AMENDMENTS TO THE DRAWINGS

Appl. No. 10/672,835
Amdt. Dated June 6, 2006
Reply to Office action of Apr. 6, 2006

Figure 1 of Andersson

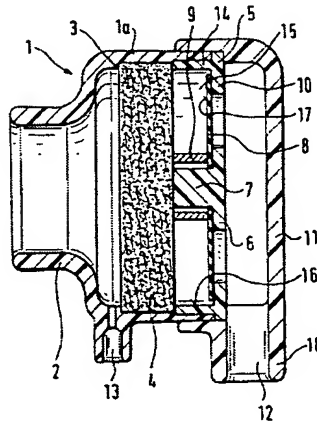
With respect to limitation (1), the Examiner asserts that Andersson discloses a filter laying against a number of ribs located in the bottom of the valve housing by reference to Figure

1, reference objects 4 (the purported filter) and 10 (the purported rib). However, as can be seen in Figure 1 of Andersson, which is copied below for the Examiner's convenience, the purported rib (reference 10 below) is not a rib at all but is instead a ring. Moreover, the purported rib is not located at the bottom of the valve housing but is instead located at the top. Even further, the purported filter (reference 4 below) is not shown to be laying against the purported rib.

With respect to limitation (2), the Applicant believes that the Examiner may have understood the claim limitation. In asserting that this limitation is met, the Examiner states "fig. 1 seems to depict filter parallel to the ribs." However, this claim limitation does not call for the filter to be parallel to the ribs. Instead, this limitation calls for: (a) the nipple to open into a space defined by the ribs and the bottom of the valve housing; and (b) the nipple to also open into the filter parallel to the extension of the filter. Both requirements (a) and (b) of limitation (2) are clearly not taught or suggested by Andersson because Andersson does not teach ribs (see discussion above) or a space defined by ribs and the bottom of the valve housing. Moreover, the nipple in Andersson does not open **into** the filter. Instead, the nipple of Andersson opens into the space to the left the filter, as shown in the Figure above.
